THIS SHEET MARKUP DRAWING IS GENERATED FROM ENGINEERING PDF & REFERRING APPROVED ENGG ISOMETRICS. ENGINEERING ISOMETRICS TO BE REFERRED FOR REVISION APPROVAL INFORMATION & IN CASE OF ANY DISCREPANCY DATA GIVEN IN ENGINEERING ISOMETRIC SHALL GOVERN

PWHT	CHEMICAL CLEANING	PIPING MATERIAL CLASS	DESIGN		OPERATING		TEST PRESS. (PSIG)	TEST MEDIUM	RADIOGRAPHY %		INSULATION		TRACING	PAINTING	STRESS SYS NO.	LINE ID
			TEMP. (DEG. F)	PRESS. (PSIG)	TEMP. (DEG.F)	PRESS. (PSIG)			SHOP	FIELD	THK. (MM)	TYPE				
N	NOTE-8	9CA2P01	560	1157	510	971	3160 3150	WATER	100	100	90	HC	NA	APCS-11C		VT-D2314AN9-230A

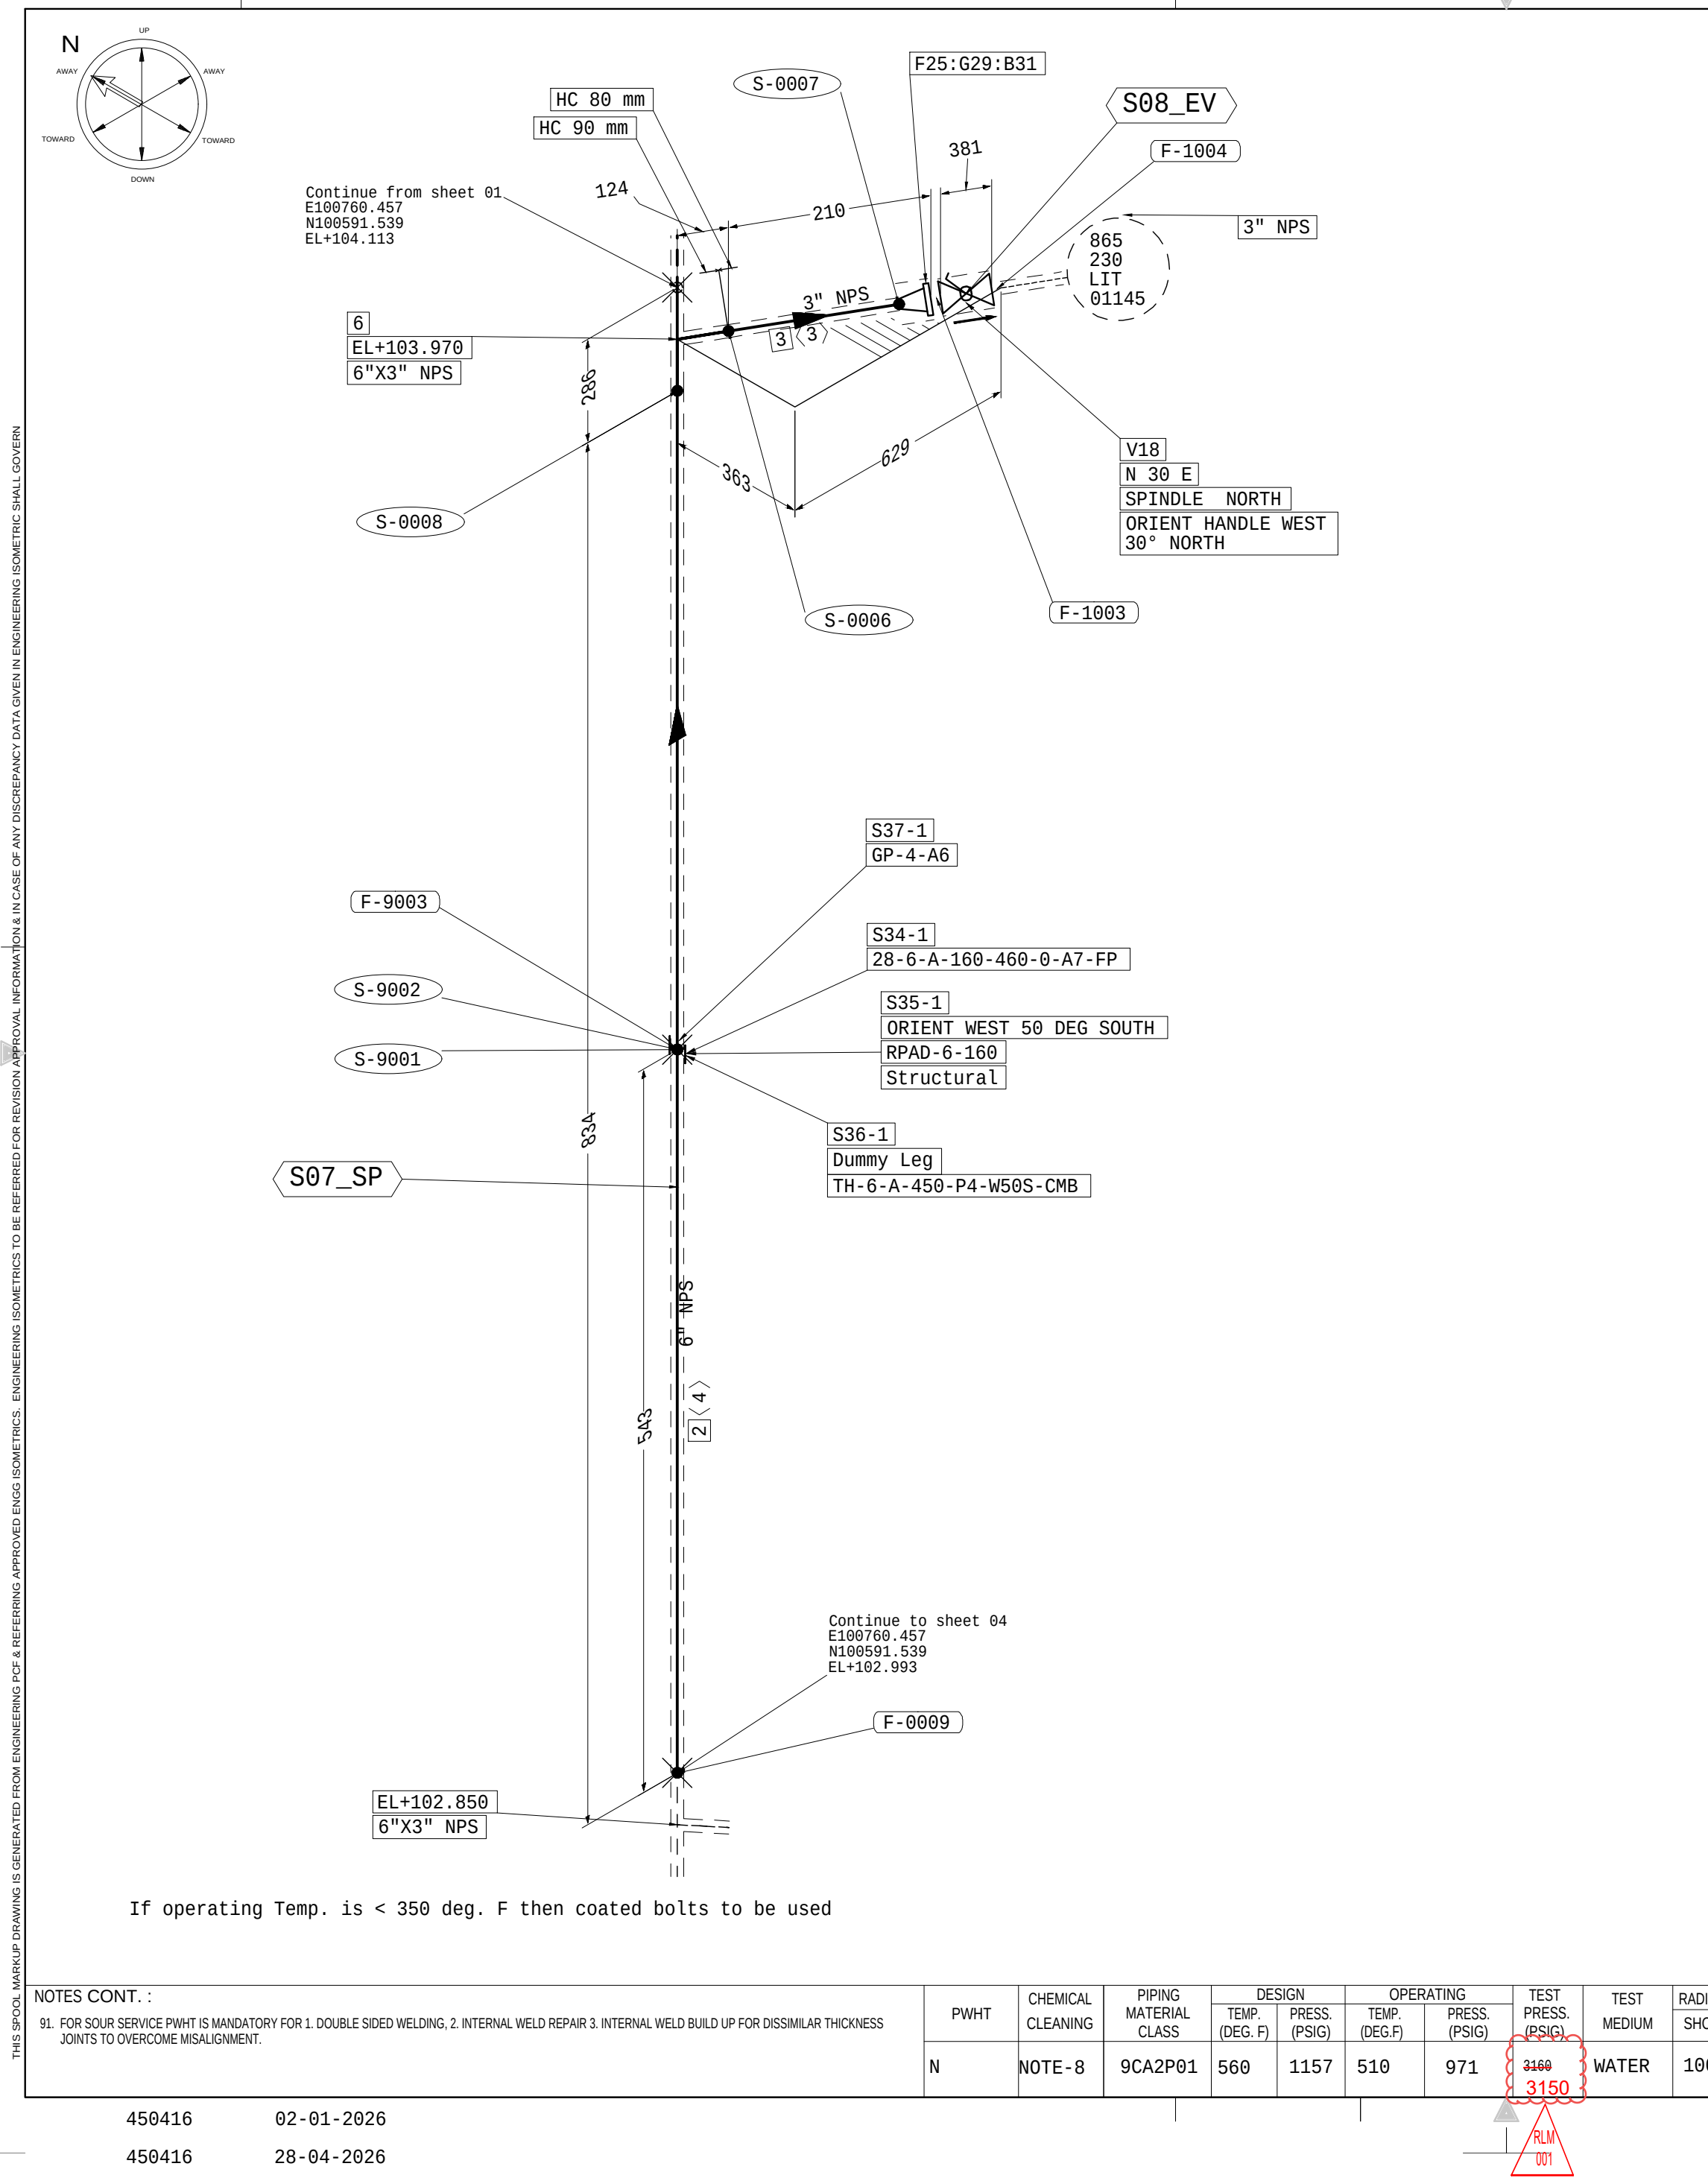
If operating Temp. is < 350 deg. F then coated bolts to be used
